Re: The continuing need to prepare a Programmatic Environmental Impact Statement in connection with plans to expand plutonium pit production at the Los Alamos National Laboratory in New Mexico and the Savannah River Site in South Carolina.

POTENTIAL ENERGETIC CHEMICAL REACTION EVENTS INVOLVING TRANSURANIC WASTE AT LOS ALAMOS NATIONAL LABORATORY

Defense Nuclear Facilities Safety Board Technical Report

Figure 2. Area G Dome 49

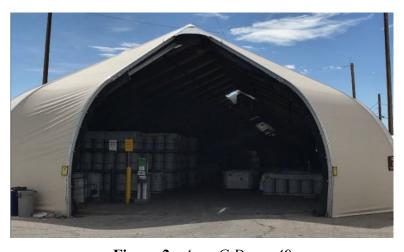
Area G does not have multiple layers of protection to prevent or mitigate a chemical reaction event. Area G stores transuranic waste in domes that typically consist of an aluminum frame with a fabric shell (Figure 2). While several storage domes have general service fire suppression capabilities, the Area G safety basis allows transuranic waste to be stored in domes that lack a fire suppression system. Area G personnel perform weekly radioactive contamination monitoring; however, the storage domes do not have continuous air monitors. Further, Area G personnel recently rolled back the Area G radiological buffer area, and associated radiological work permits no longer require workers to perform a radiological survey prior to exiting Area G.
